**Meeting Date:** Tuesday 17 September 2013  
**Location:** Committee Room 2, Level 5, Civic Centre, 1 Devlin Street, Ryde  
**Time:** 5.00pm

**Previous Items:** 2 - 305 BLAXLAND ROAD & 5-7 NORTH ROAD, RYDE. LOT 1 DP1069680 & LOT A&B DP 414322. Local Development Application for alterations and additions to San Antonio da Padova Nursing Home. LDA2012/247. - Planning and Environment Committee - 7 May 2013  
**File Number:** grp/09/5/6/2 - BP13/1312

**Date lodged: 17 July 2012 (latest amended plans received 28 June 2013)**

The following plan and elevation shows the location of the Level 1 terrace in question.

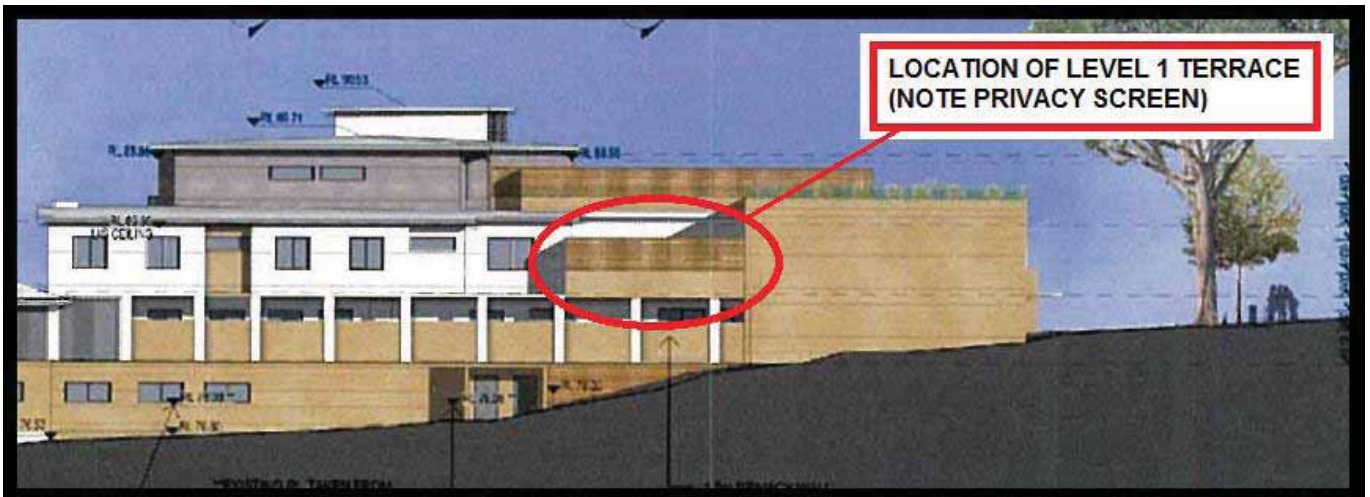
Comment: The objection notes that the Level 1 roof terrace is close to the neighbouring building and could potentially be used by multiple occupants/visitors. Although a privacy screen is proposed to the terrace, the objection states that this will not ensure acoustic privacy is maintained. The objection also states that the development (overall) contains numerous other terraces and outdoor areas so that replacement of one small terrace is a reasonable request.

The applicant was also advised of this request, but has not agreed to the suggested amendment (to a landscaped roof). In response, the applicant has made the following comments in relation to the Level 1 terrace:

- *in addition to be being separated by 9m from No. 1 Aeolus Avenue, this small terrace is provided with a 1.8m solid screen for the entire length of its eastern edge, and the size of the balcony is further restricted by the provision of a planter box adjacent to that screen; and*
- *the 1.8m high screen sits on top of the planter box, and will therefore prevent any direct line of sight between a person on this terrace and a person on the balcony of Level 2 of No. 1 Aeolus Avenue.*

*For these reasons we consider that this terrace will not result in any adverse visual or acoustic privacy impacts for the adjacent building. Our client therefore does not agree to converting this terrace to a roof garden. However to reinforce the intention that the function of this terrace is a quiet, passive area, our client is agreeable to a condition that would restrict the use of this particular terrace to between 8am and 8pm.”*

The applicant's response regarding the Level 1 terrace is supported. Whilst the terrace will be located off the living/dining and quiet sitting area, it is relatively small in size (4.52m x 7.5m), and is secondary in nature to another larger terrace on the northern side of the new building. The solid 1.8m screen and planter box already indicated on the plans are considered sufficient to preserve privacy for the neighbouring building. It would be unreasonable to require that this small terrace be deleted, however it is reasonable to require a limitation on the hours of use as suggested by the applicant. Condition 73 is recommended in this regard.

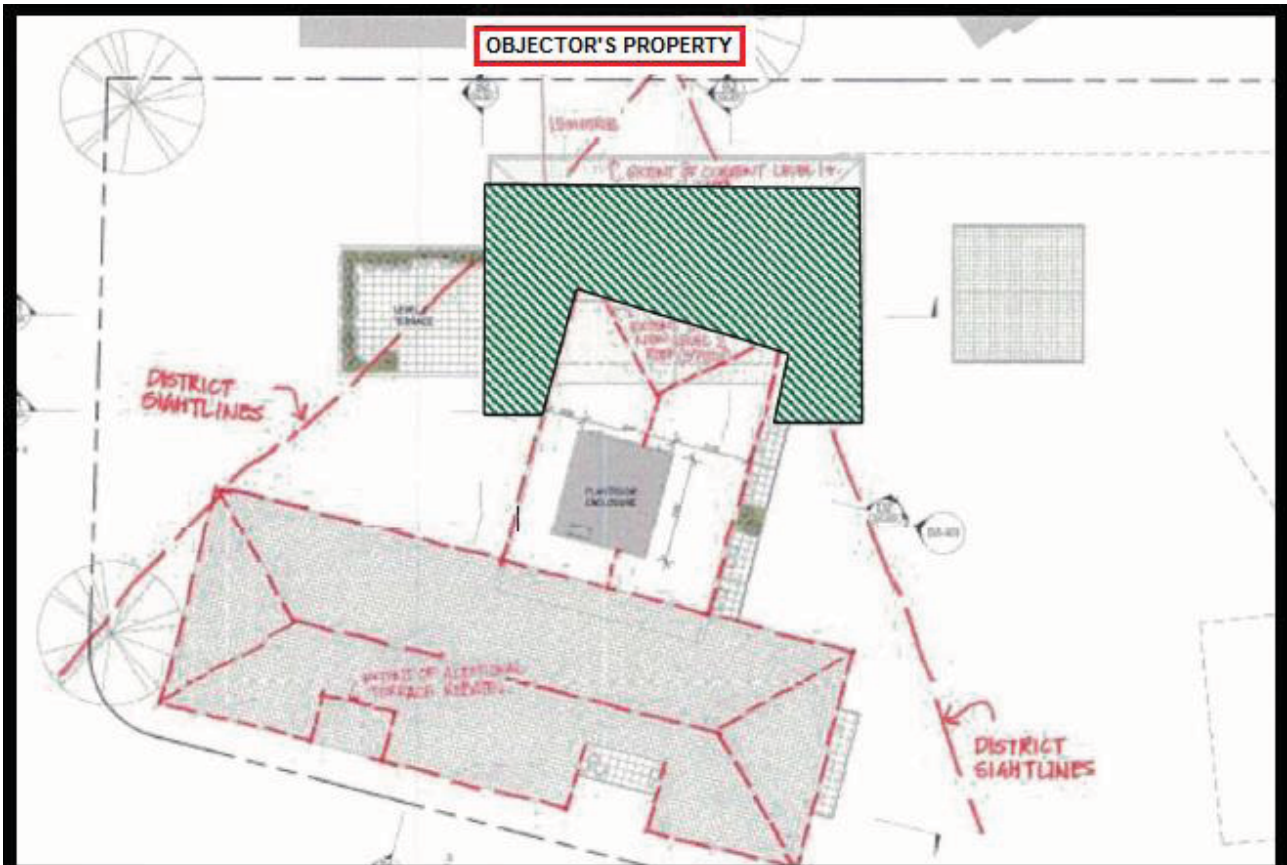
Firstly, in regard to the proposed additions to the eastern side of the building, the main issue of concern (in the previous plans) was the height of the building where it was immediately adjacent to the eastern boundary. At this location, the height was proposed to be 12.12m (measured to ceiling level) and 4 storeys in height in the original plans.

The proposed height at the point closest to the eastern boundary has been reduced so that it is now a maximum 9.45m. The maximum overall height (ie measured vertically from any point on the ceiling of the topmost floor of the building to the ground level immediately below that point) is now proposed to be 10.62m, however this is now more towards the centre of the building and away from the eastern boundary. The following plans (roof plan and south elevation) show the heights of the proposed building at various locations. It is noted that these drawings show the maximum height to be 11.05m; however this is to the roof of the plant room which is not a “floor” as defined in the SHSEPP.

The main issue of concern regarding the height on the eastern side related to its impacts on the adjoining residential flat buildings to the east (in terms of visual bulk and scale, and also loss of view/outlook). In the amended plans, a significant amount of floor space (210m<sup>2</sup>) at the highest level (level 2) at the eastern side has been removed, and so the impacts on the adjoining residential flat building are also significantly reduced. The following drawing is a sketch of the roof plan provided by the applicant to show where the floor space has been removed (shown hatched green below).

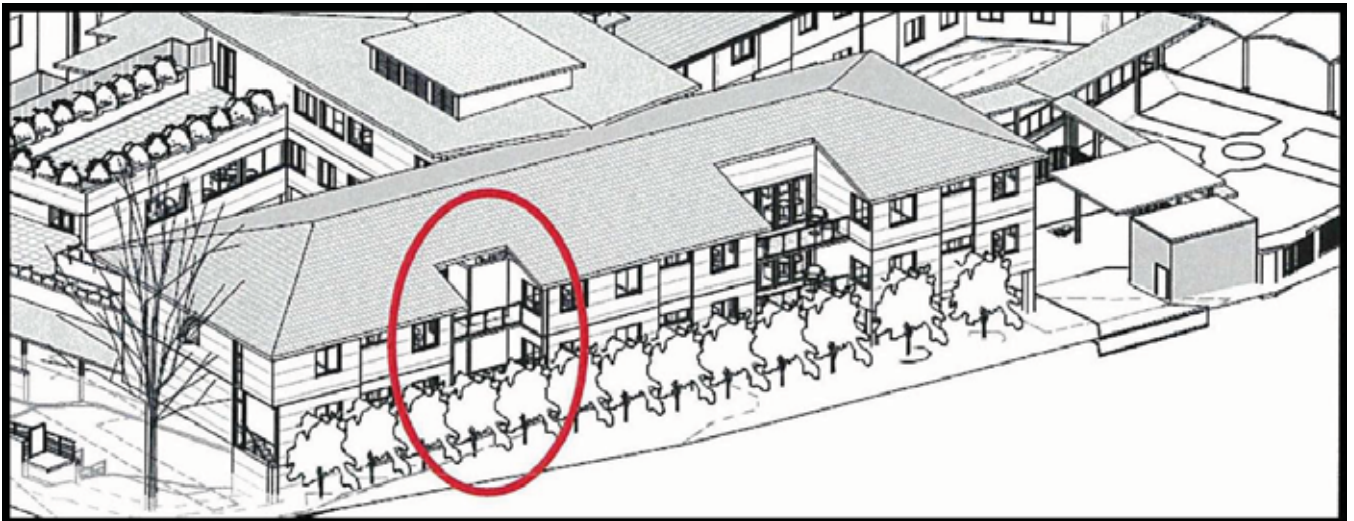
In relation to the proposed new building on the western side fronting North Road, the main issues of concern related to the impacts caused by a lack of architectural modulation along the North Road frontage. The amended plans have also satisfactorily addressed this issue with the provision of an additional indentation at the northern end of this building (an additional outdoor terrace at both levels). This indentation is shown in the following drawing (3D perspective provided by the applicant).

It is considered that the provision of this additional indentation to the building will reduce previous concerns regarding bulk and scale when viewed from North Road. The length of the building's façade to North Road now has 2 indentations to break down the overall building mass into smaller elements, and this will also be beneficial in terms of allowing a greater amount of natural light into more of the building's internal space.

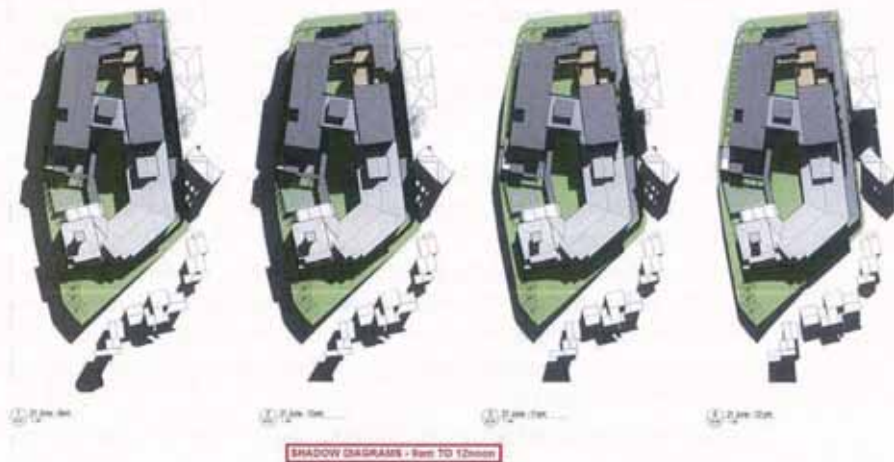
Comment: The shadow diagrams (for the winter solstice 21 June) from the proposed development are provided below (and larger A3 sized plans are included in the Councillors Attachments package attached to this report). Given the orientation of the land, the shadows from the development would fall mostly onto the street (North Road to the west) during the morning period (ie 9-10am), then only within the site (10am to about 1pm), and would then only begin to affect the neighbours to the east from 1-2pm onwards. Such an impact would be considered to be reasonable considering the scale of the development.

Concerns that the western side of the buildings at No 1 and 3 Aeolus only receive sunlight after 1pm (and so any impact from this development is unreasonable) are not supported. Much of the overshadowing within the adjoining site (1 and 3 Aeolus) is caused by own buildings within that site ("self-shadowing").

If the proposal was amended to address other concerns (ie height, setbacks etc as discussed throughout this report), the extent of impact – such as the length of shadows – could be reduced, however it is considered that any overshadowing would only begin to affect the neighbours after early afternoon (1-2pm) because of the orientation of the land. Overall issues regarding overshadowing onto No 1 and 3 Aeolus Ave to the east are considered to be minor in the context of this development.

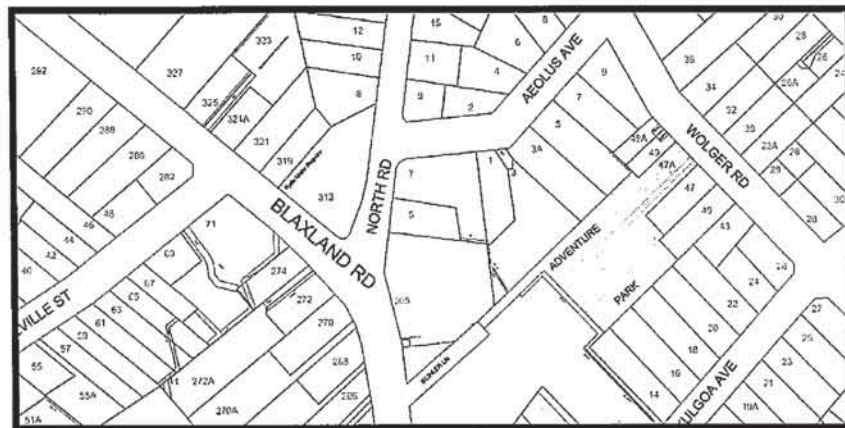
Assessment Officer's Comment: The above views are obtained from those living area and bedroom windows, as well as balconies of the units facing west, and such views are available in either a standing or a sitting position (depending on the location of the unit enjoying the view).

The shape of the allotments (see allotment plan below) is somewhat unusual, however the views from 1 and 3 Aeolus Ave would be considered to be side views over the subject property, which are recognised in *Tenacity* as being more difficult to protect.

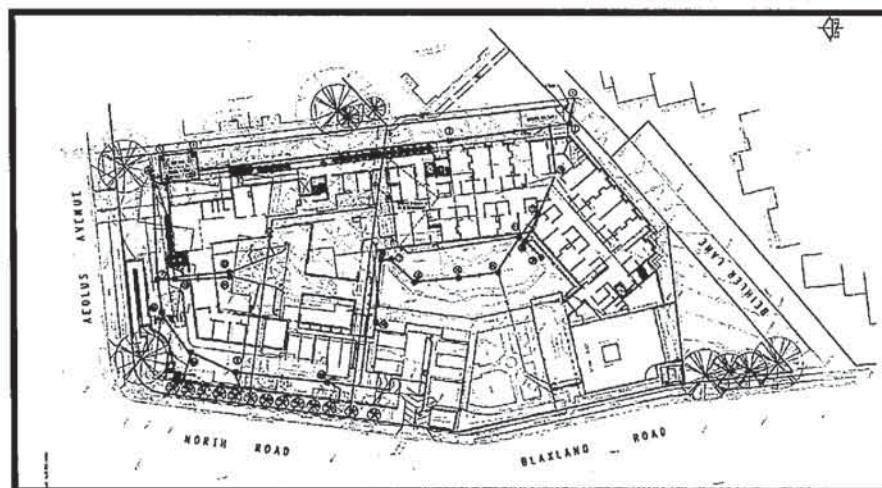
*With respect to stormwater drainage, I have reviewed the stormwater drainage plans prepared by Taylor Thomson Whitting Consulting Engineers and generally the plans comply with Council's DCP 2010, Part 8.2:Stormwater Management. If Development Consent were to be granted, engineering conditions would be imposed.*

Comment: In summary, in terms of stormwater disposal, the proposal involves connecting new underground stormwater pipes (with the provision of an additional on-site detention (OSD) tank) into the existing pipes at the southern end of the site which then connects into existing drainage system in Adventure Park (to the south-east of the subject site). This is consistent with the stormwater disposal arrangements previously approved by Council and constructed to completion as part of the previous development approval for this site (LDA2001/207 issued in November 2001). This will in effect improve the stormwater management of the site by increasing the OSD storage capacity which will reduce the discharge runoff into the trunk drainage system in Adventure Park.
